## **Access Compliance Report Public Rights-of-Way** (Curb Ramps)

Cross Street: DOWNY BIRCH RD Intersection ID: 50608 Main Street: DENBUR DR Location: NW Initial Pass/Fail: Fail **Overall Compliance: No** ADA ID: FB6844329054 Ramp Type: Combination2 Severity Score: 13.75

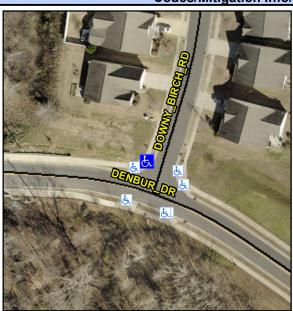
Street 1 Name StopSign Stop Condition-Street 1 DOWNY BIRCH RD Street 2 Name N/A Stop Condition-Street 2 N/A Possible Solutions: Compliance Description Remove & Replace Entire Ramp. N/A N/A N/A N/A N/A Yes Surveyor Notes: N/A LT RP < 5% N/A N/A N/A N/A PROW/ADA: N/A Not Found, R304.5.3, R304.3.2 N/A
